DRWG No DA-02-C
PROPOSED SITE PLAN

DA2023/0493

PROPOSED ALTERATIONS TO FRONT FENCE AND ENTRY AND UNIT 4 BALCONY AND ASSOCIATED WORKS AT 8 OCEAN ROAD MANLY 2095 SP 14402			FOR THE OWNERS SP 14402		KUBANYI ARCHITECTS NSW REG 4087 DEP 0000592 LEVEL 1, 122 VICTORIA ROAD DRUMMOYNE 2047 PH 0412 500 240 JUDITHKUBANYI@IINET.NET.AU				DRWG NoDA-A03- D PLAN AT GFL LEVEL
					Scale 1:100@A3	Date April 14 2023	Drawn jk		
								issue DA

**DRWG No DA-A09-E
SECTION B-B**

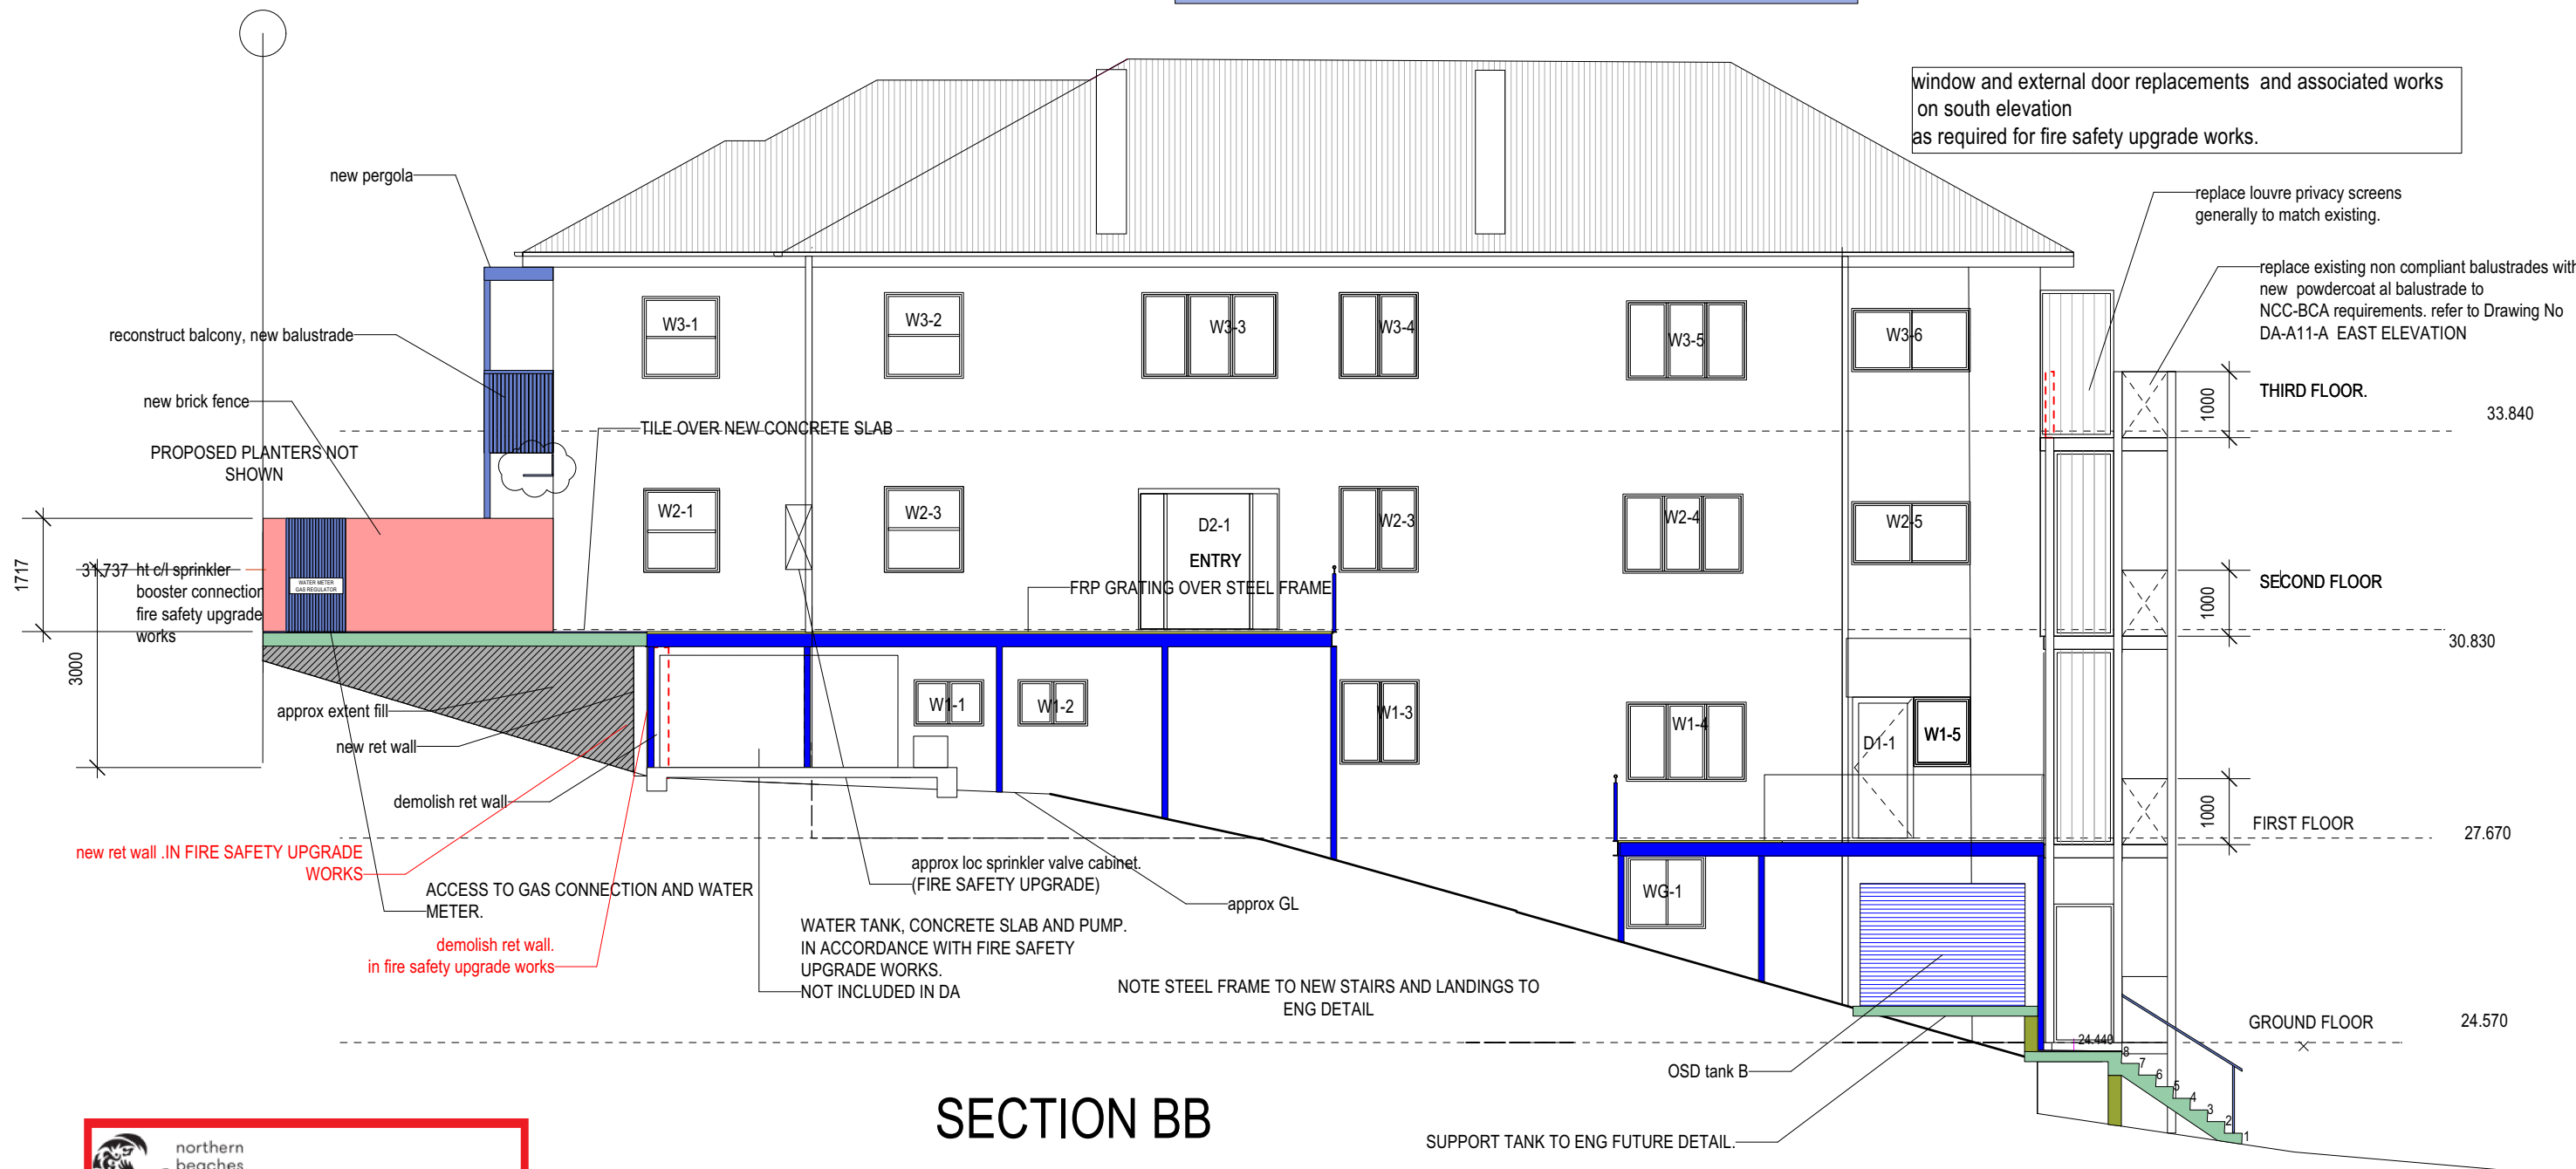
E	30.10.2023	awning required to comply with BASIX added
D	12.9.2023	new retaining wall , demolition of existing added to fire safety upgrde works- deleted from DA
C	7.8.2023	OSD tank location shown
B	25.7.2023	reference to currently approved DA 2020/0875 deleted.new landing and stairs shown this DA . front fence height reduced.

DRWG No DA-A10- D
SECTION C-C

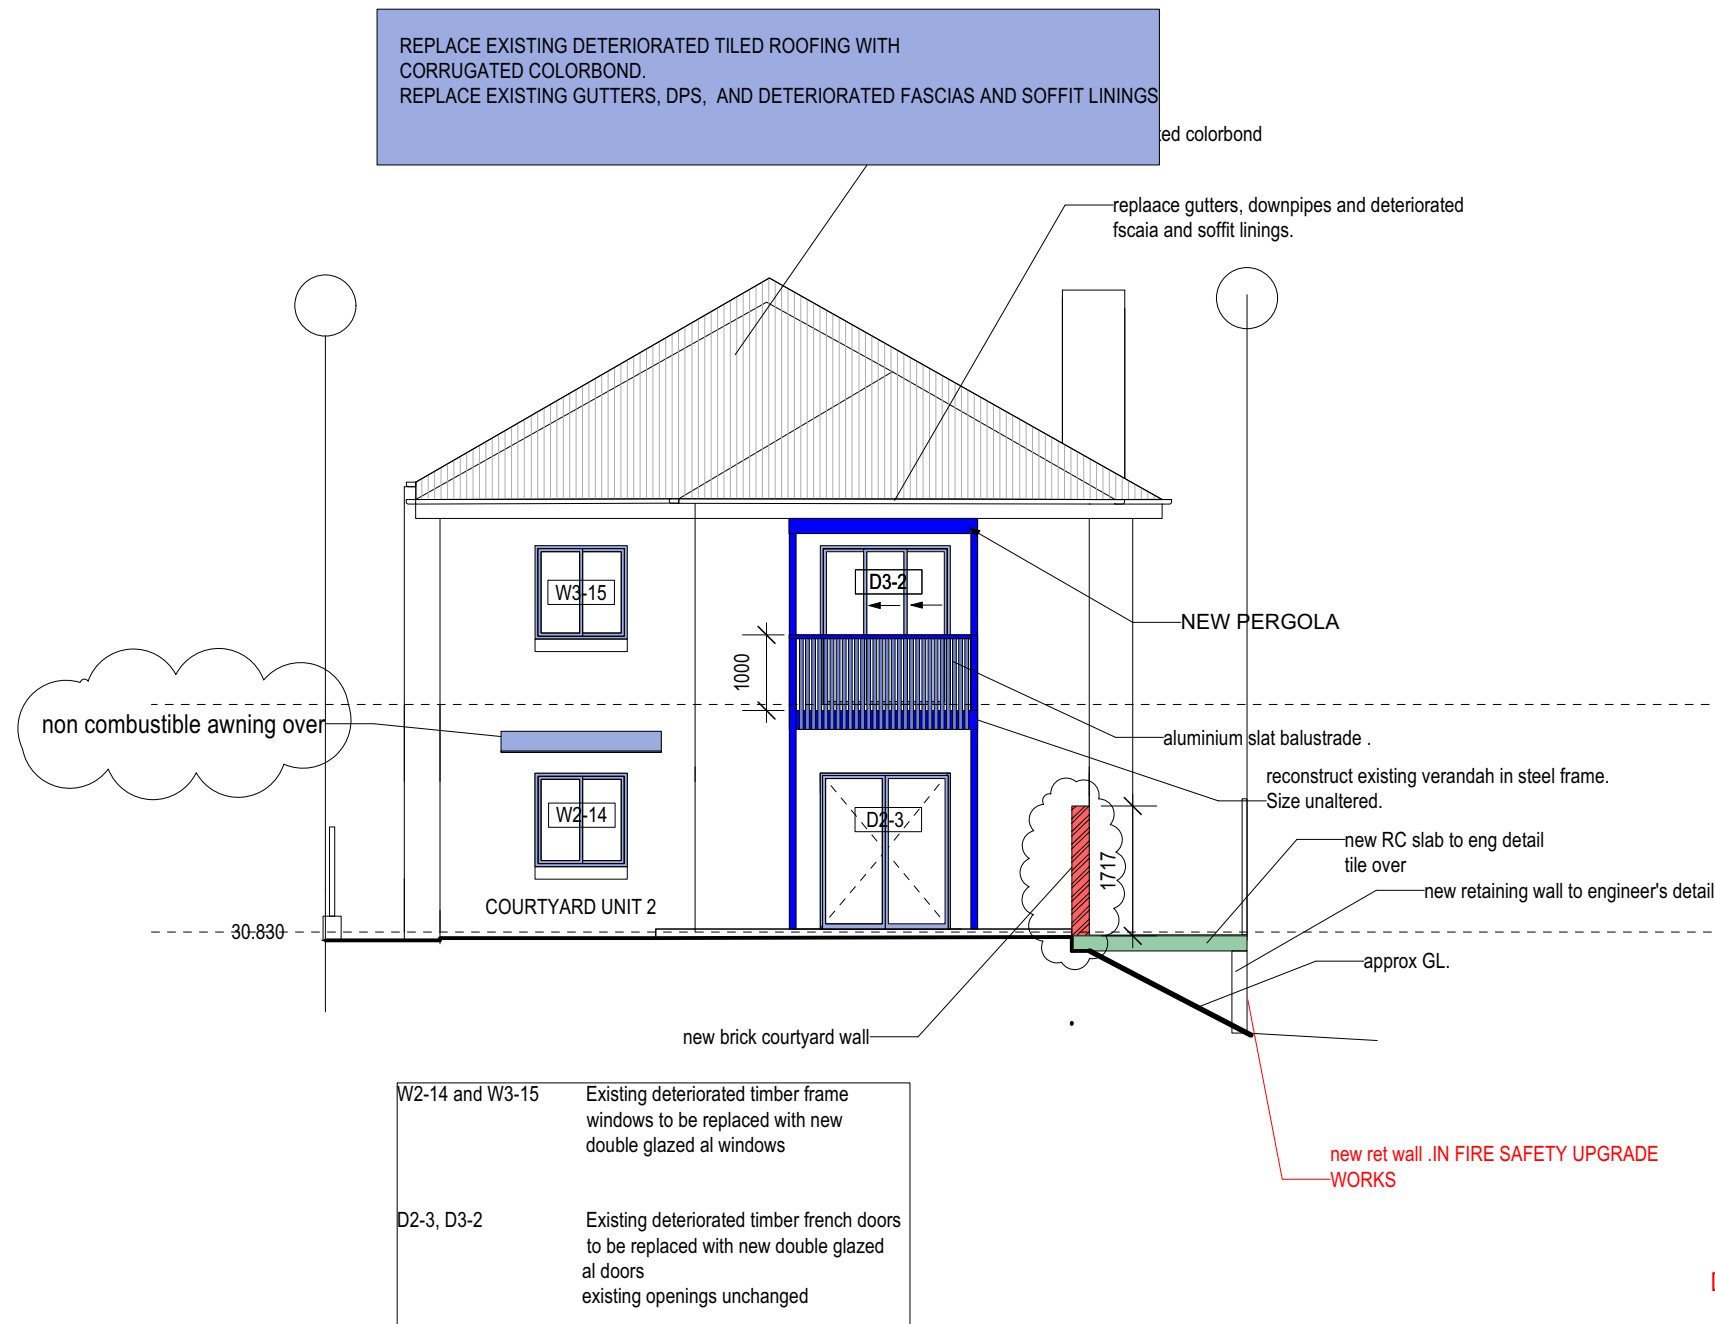
D	30.10.2023 W2-14	BASIX commitments added, including awning over
C	5.9.2023	new retaining wall , demolition of existing added to fire safety upgrade works- deleted from DA
B	25.7.2023	Front fence height reduced.

DRWG No DA-A11-E
EAST AND WEST
ELEVATIONS
&
BASIX COMITMENTS

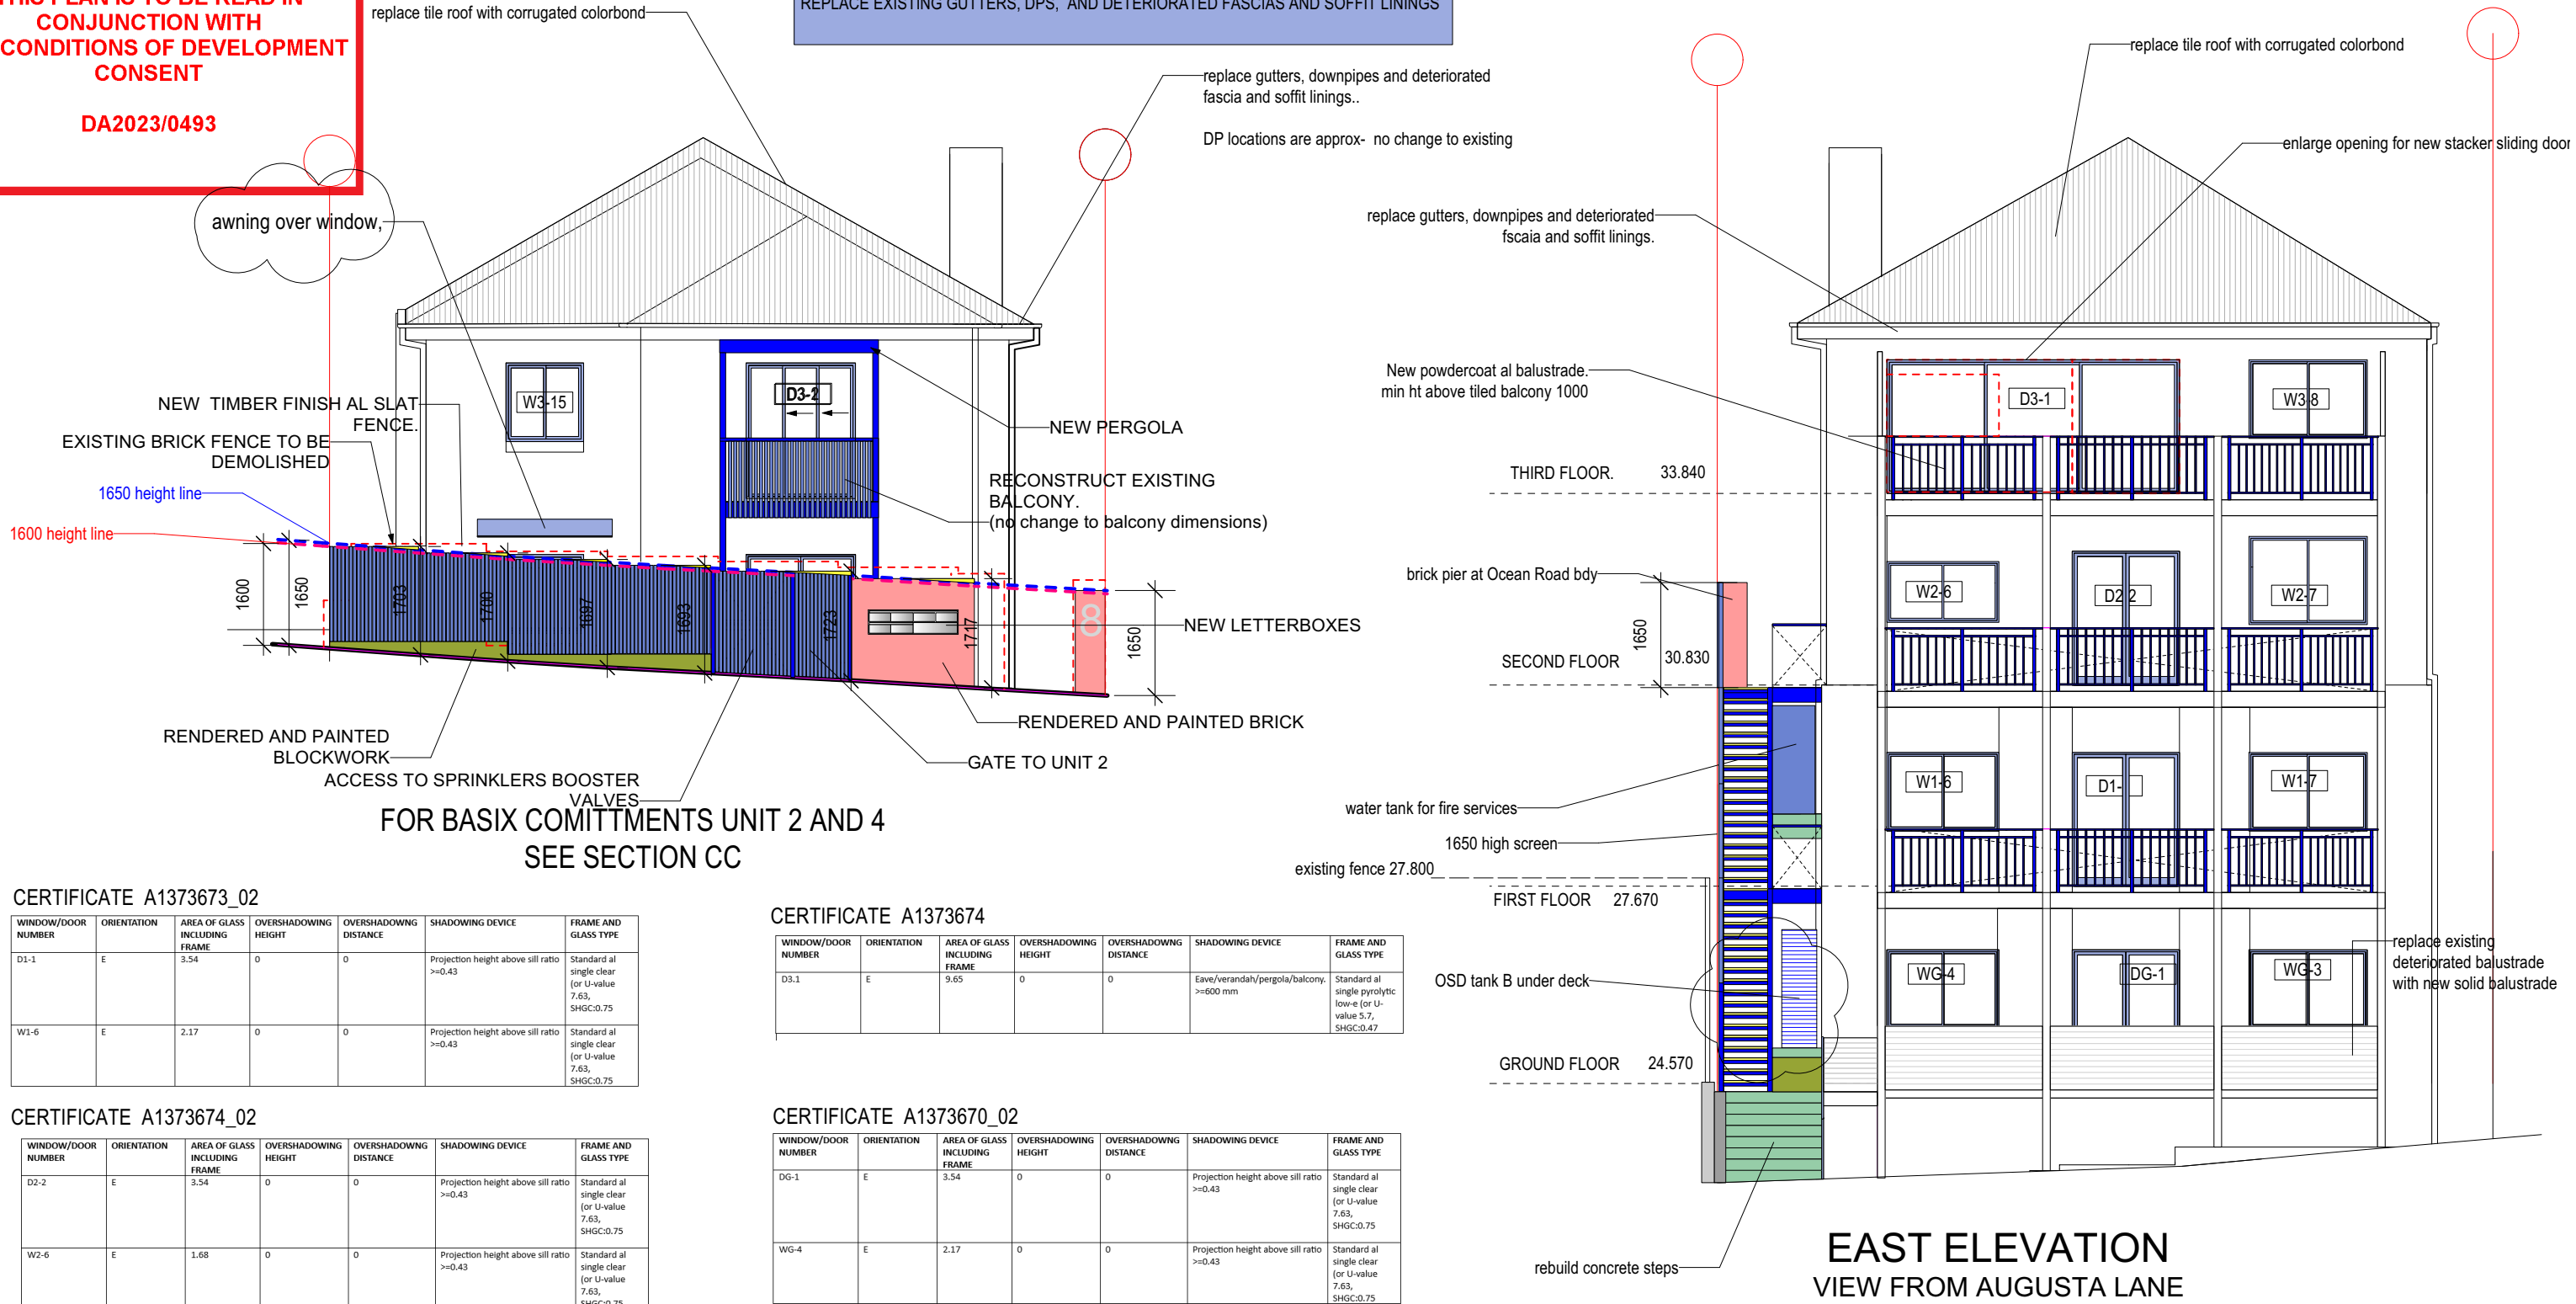
E	30.10.2023	BA
D	12.9.2023	OSD tank location amended
C	7.8.2023	OSD tank location shown
B	25.7.2023	reference to currently approved DA 2020/0875 deleted. New landing and stairs shown this DA Front fence height reduced

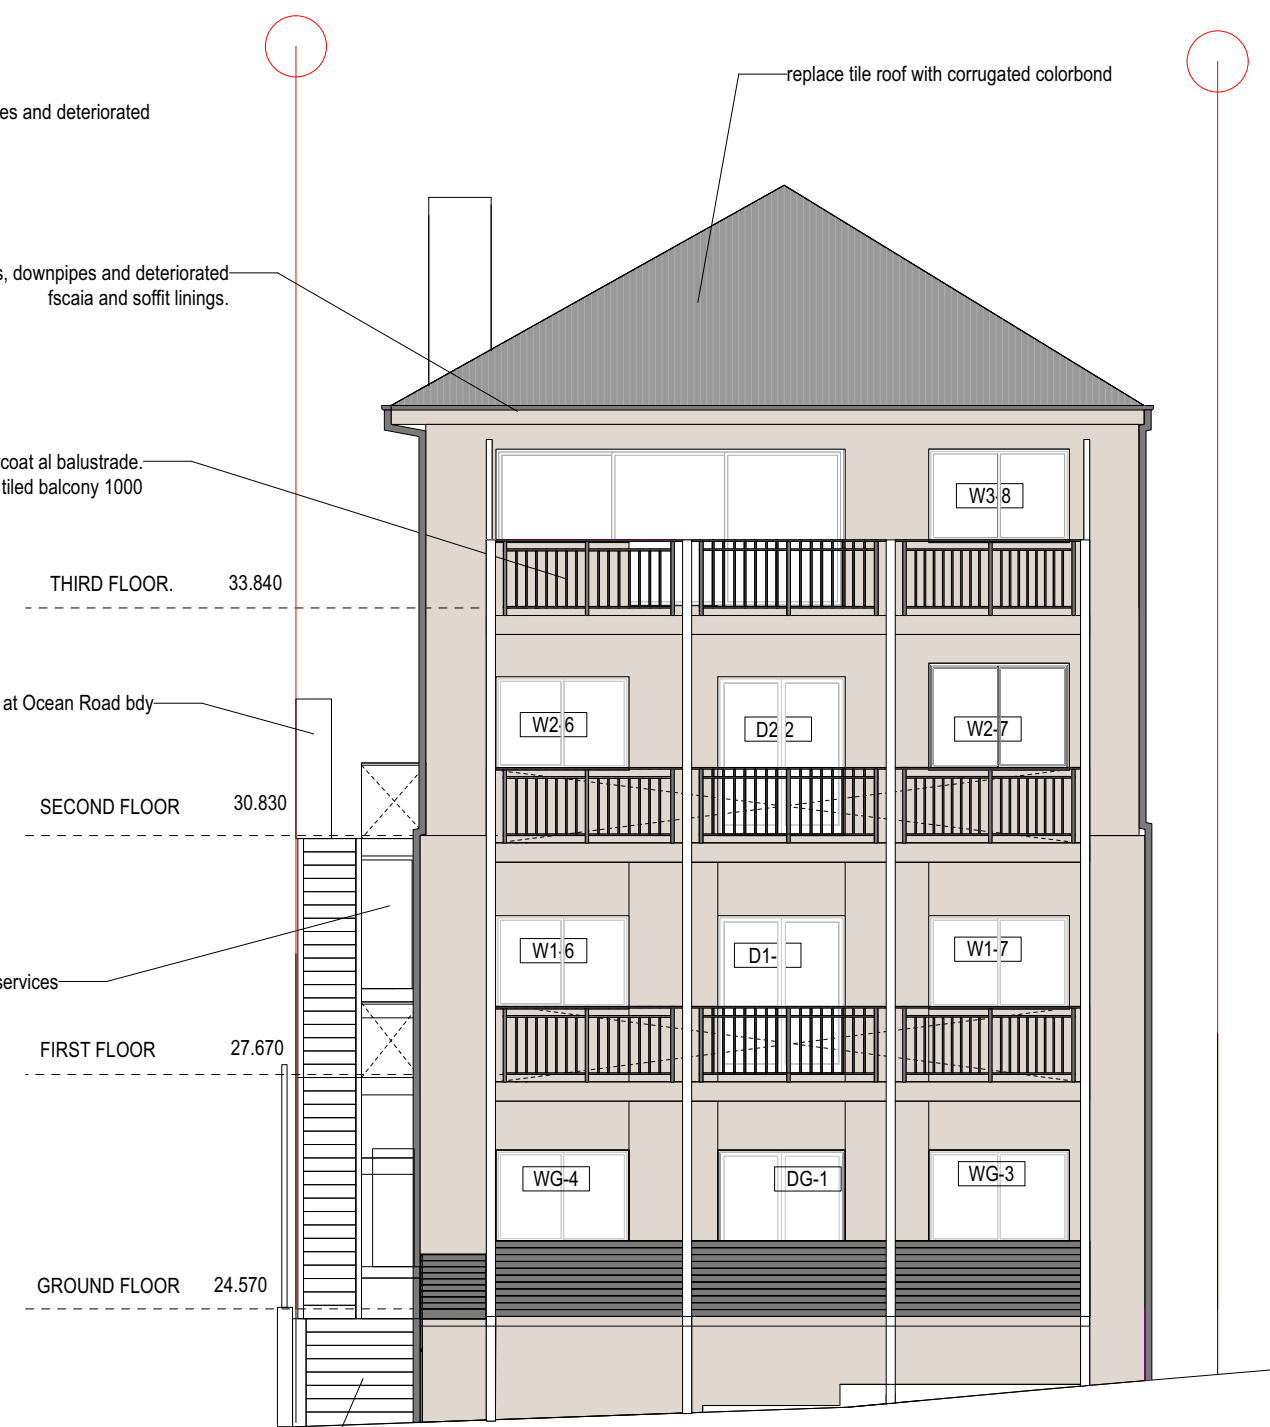
E	30.10.2023	awning required to comply with BASIX added
D	12.9.2023	OSD tank location amended
C	7.8.2023	OSD tank location shown
B	25.7.2023	Front fence height reduced
